This is to certify that CITY OF PORTLAND / City of Portland / Trades Division has permission to PATHS/CBHS - School Department of - Construction for Code Review AT 174 ALLEN AVE L 343 C013001

**PORTLAND PUBLIC SCHOOLS
PATHS – CBHS
NFPA 101 2003, CODE REVIEW**

**March 3, 2008,
Revised April 1, 2008**

**IMPROVEMENTS
DWG 3 OF 4**

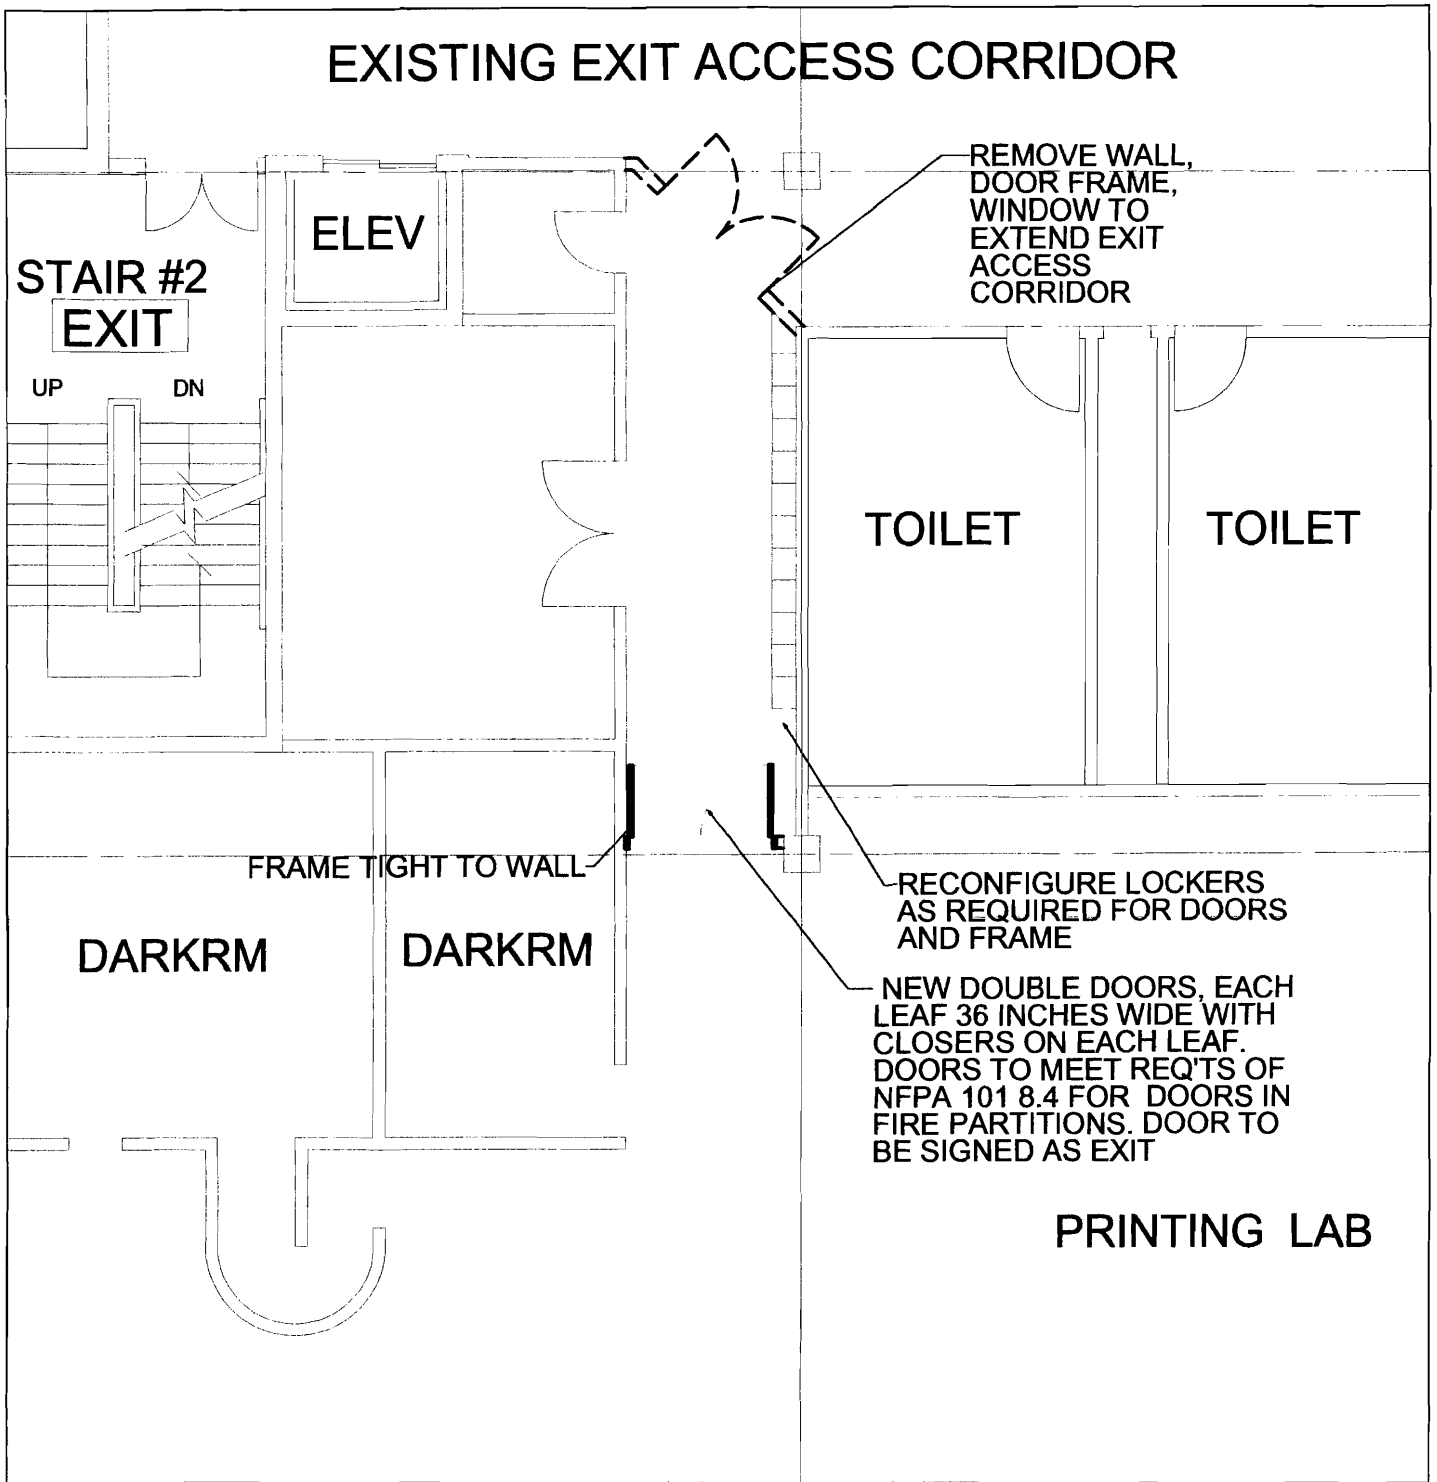
2. In the spaces created within the printing lab there is one issue, the distance from the classrooms to the exit access corridor exceeds the maximum 75 feet by approximately 13 feet. The solution to this is to move the double doors at the corridor on the west end of the space deeper into the lab. The width of this hall is over 6 feet so it will meet that requirement. The small dead end corridor created would have to meet the requirements of the 8.4 Smoke Partitions, and would be less than the 50 foot length allowed for a dead-ended corridor. Exiting signage will need to be adjusted.

**PATHS / CBHS CODE ANALYSIS
2ND FLOOR PRINT LAB - RECOMMENDED IMPROVEMENTS**

**IMPROVEMENTS
DWG 4 OF 4**

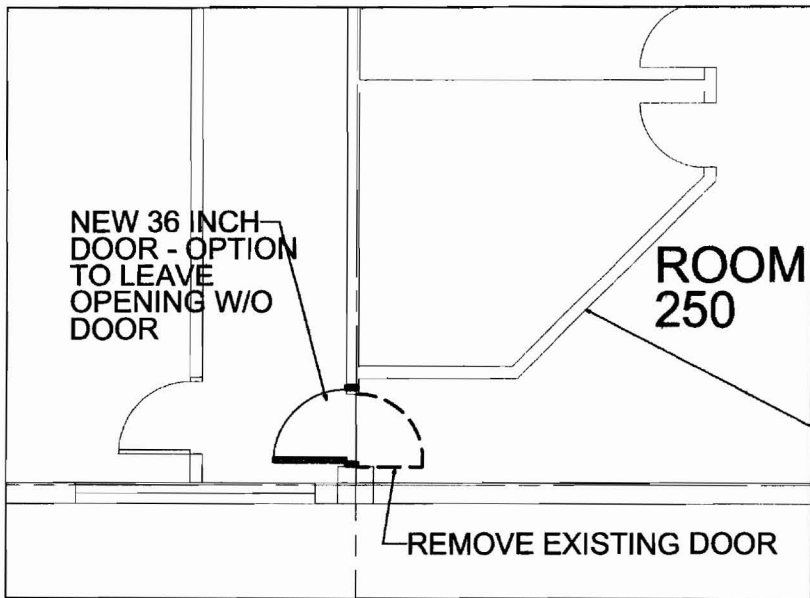
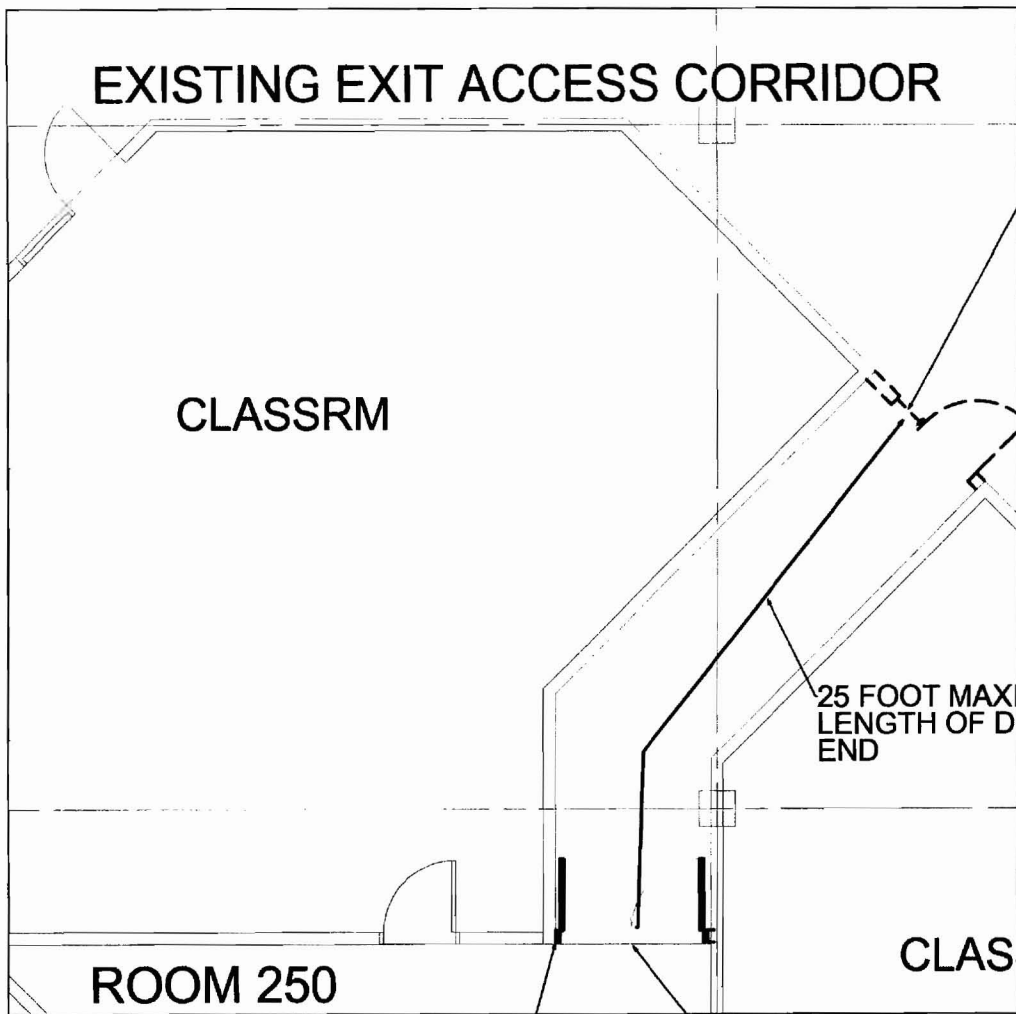
3. The classrooms around the library in Room 250 have the same issue; the distance from the most remote corner classroom to the corridor is 87 feet direct travel, and more with the library located in the path of travel. Similar to the Print Lab, the corridor will need to be extended into this space – shortening the length of travel to 75 feet or less. This doorway should probably be a double door. There is also only one exit out of this room at this time, and the maximum length of travel to that door from anywhere in this area can not exceed 100 feet. The library may have to be reconfigured to make this possible. Exiting signage will need to be adjusted.

4. With the addition of the classrooms in this area of the building and more being contemplated, an additional issue must be addressed. Both of these “suites” of classrooms are at the point where each should have a second means of egress into the Exit Access Corridor. The print lab already has 2. Room 250 is of significant concern, since it currently only has one egress to the corridor. It is appropriate to review the utilization of this space by the CBHS and the School Committee at this time, understanding that events with over 50 people are Assembly Use and that classification requires a 1-hour fire separation from Education Uses, as well as other significant code restrictions. Reversing or removing the door into the print lab and allowing exiting from Room 250 into that space should be considered to create a second egress way out of the space that is remote from the doorway into the Exit Access Corridor. Exiting signage will need to be adjusted.

NEW DOUBLE DOORS, EACH LEAF 36 INCHES WIDE WITH CLOSERS ON EACH LEAF. DOORS TO MEET REQ'TS OF NFPA 101 8.4 FOR DOORS IN FIRE PARTITIONS. DOOR TO BE SIGNED AS EXIT

REDO EXIT SIGN TO DIRECT TO NEW DOOR

**PATHS / CBHS CODE ANALYSIS
ROOM 250 2ND FLOOR - RECOMMENDED IMPROVEMENTS**
